Access Compliance Report Public Rights-of-Way (Curb Ramps)

Main Street: LA_LOMA_DR Cross Street: RYCROFT_RD Location: SW

ADA ID: RPRK211012134126 Ramp Type: Type 1 - Perpendicular Diagonal Initial Pass/Fail: Fail Overall Compliance: No Severity Score: 15

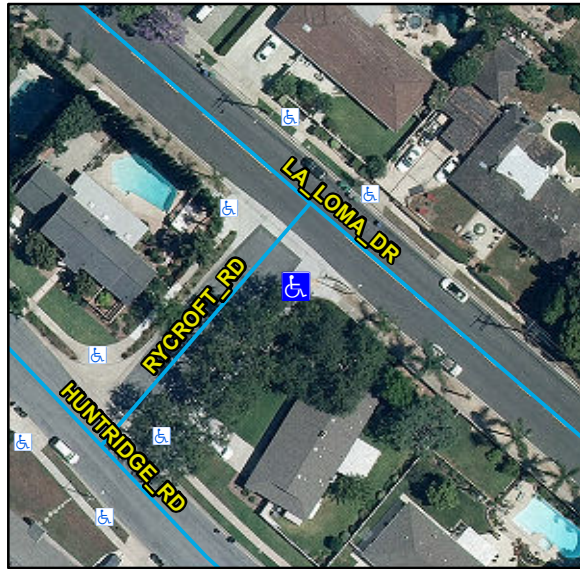
Remove & Replace Curb Ramp With Two New Directional Ramps or Equivalent.

R304.2.2, STD 1115
